Town of Breckenridge
Planning Commission Agenda
Tuesday, May 15, 2012
Breckenridge Council Chambers
150 Ski Hill Road

Planning Commission Staff Report

As-Built
Exterior Elevations
Scale: 1/4" = 1'-0"
Date: 11-08-2011

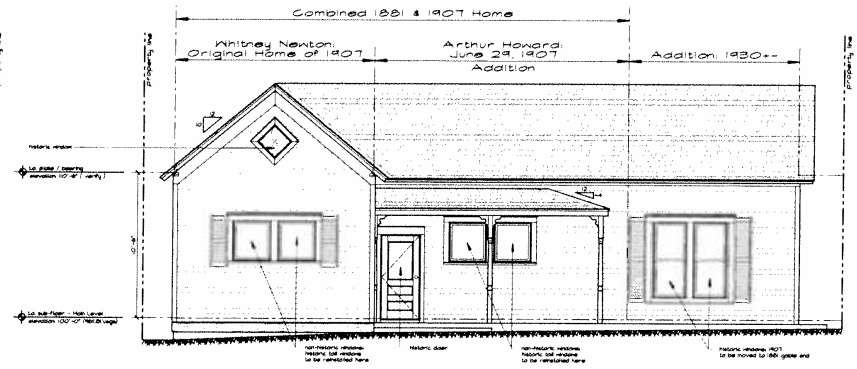
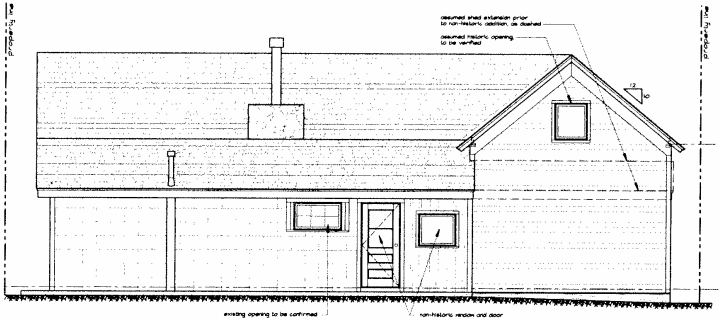
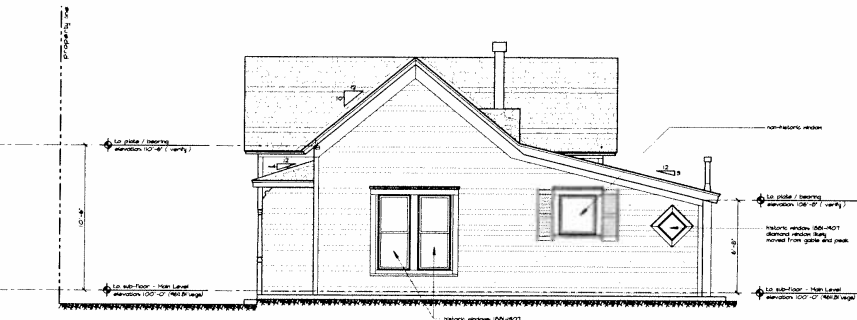
1. Adding a full porch with upper level deck over the main entry on the west elevation of the non-historic portion of the house.
2. Adding a door where a window is currently on the upper level of the non-historic portion of the house to access the proposed deck.
3. Adding four ‘Solatubes’ (instead of skylights) on the east-facing roof of the historic portion of the house.
4. Enlarging the existing historic openings of the windows (these windows are non-historic) on the west elevation of the historic portion of the house. New windows would then be added.
5. Adding a new window on the west elevation of the historic portion of the house.

The applicant is proposing to add four ‘Solatubes’ on the east facing (not primary façade) roof of the historic portion of the house. These are small (1/2 basketball-sized domes) that sit about 12-inches above the roof that allow light into the house. Compared to skylights, there is a reduced loss of historic fabric. Light is transferred in a manner similar to fiber optics. These are smaller than typical domed skylights and will have less impact on the existing fabric. However, they are domed in shape and site above the roof (not flush).

The proposal is to remove portions of the historic log fabric to install the larger windows. Staff has identified four Policies and one Priority Policy in the Handbooks that do not support this action.

Staff has identified the policies that fail and incur negative points for this proposal. The Planning Department recommends this proposal return for another hearing with a plan in substantial compliance with the Historic Handbooks of design Standards and the Development Code.

SOUTH ELEVATION

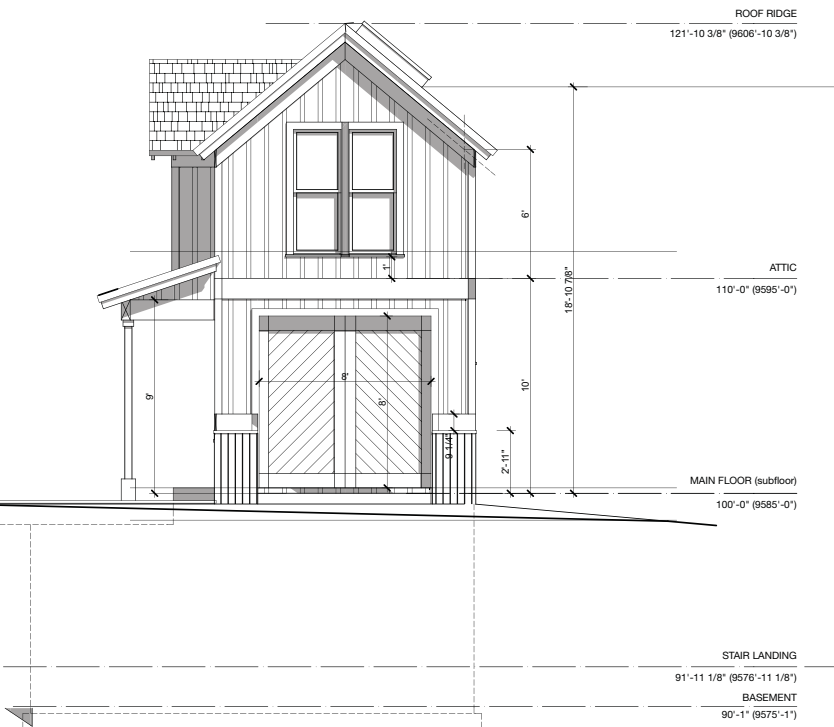
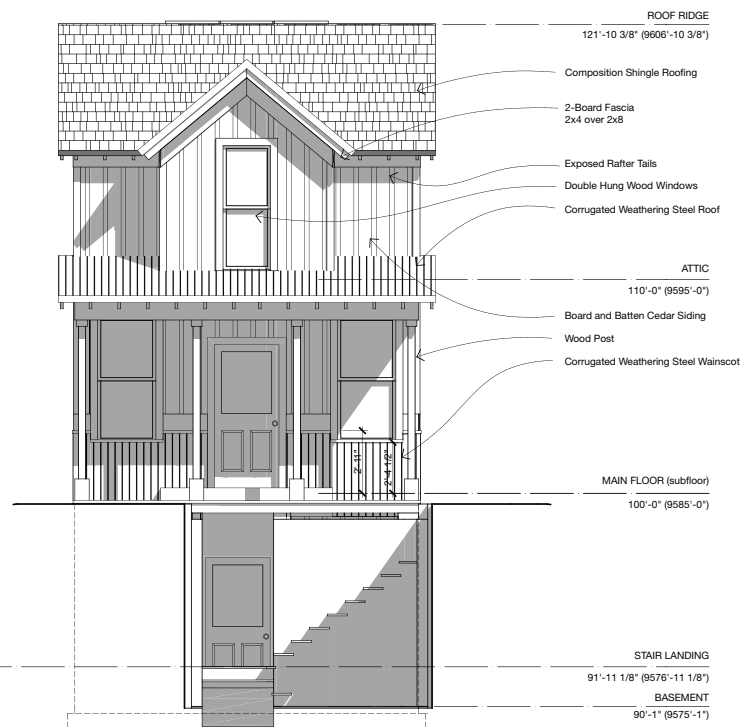
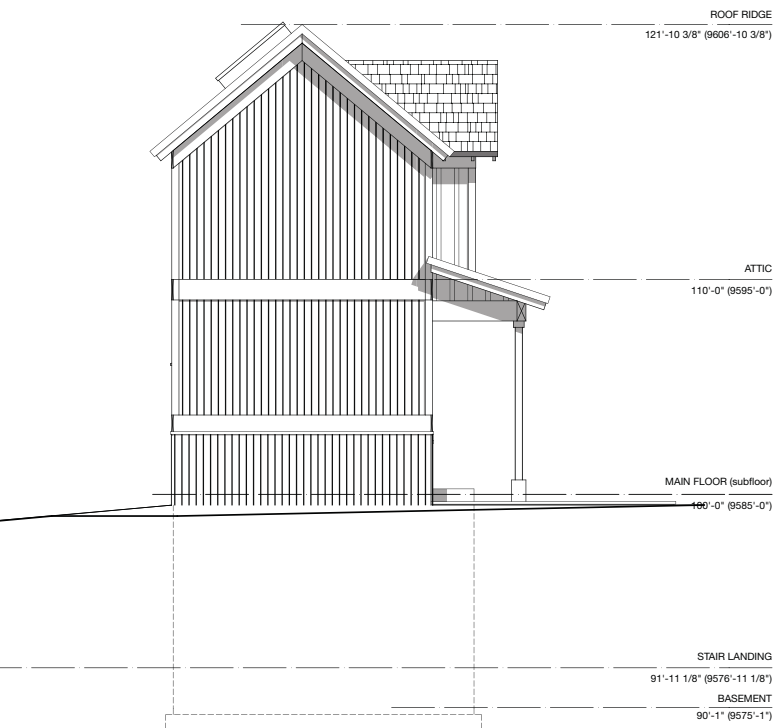
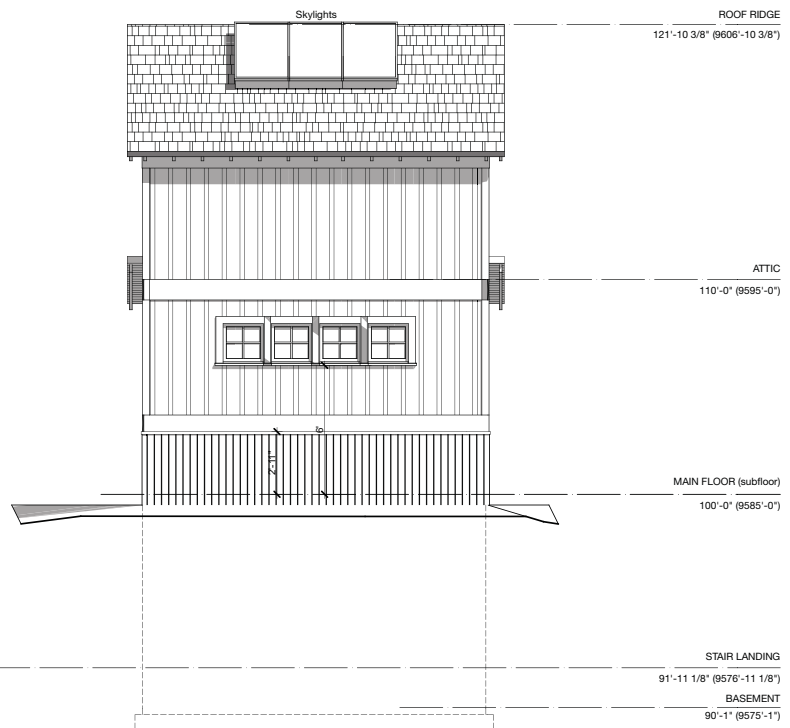
The applicant has indicated that reclaimed board and batten siding, the old wooden siding from the remodeled Fatty's Pizzeria, is to be used on the portions of the exterior of the outbuilding. The drawings also show a corrugated steel wainscot at the base of three sides of the building. The north elevation is fully faced with

An external stair accesses the lower level of the apartment in a concrete stairwell. At the last submittal, the walls of the stairwell were proposed as plank-textured exposed concrete. These drawings do not indicate any finish. Policy 5/R states that exposed unfinished concrete is an "Inappropriate exterior building material". We are suggesting the concrete be finished and noted on the drawings at the next submittal.

The drawings show that the outbuilding will have a gable dormer on the west elevation with a full porch below. (Staff notes that the historic house has no porch.) The windows are large double hung and vertically orientated. The door is wooden with a 1/2-light of glass.

The drawings show the new building to be 3-feet off the north property line (-3 points) and 11-feet of the east property line (-3 points). Hence, negative six (-6) points will be incurred for not meeting two of the relative setbacks.

At this review, the key issue for this proposal is the lapse between reviews by the Planning Commission and the Code changes that have been implemented since. At this time the proposal is failing Absolute Policy 81 for the massing of the out building being larger than the historic structure. We anticipate changes being submitted for the next hearing to avoid this failure.
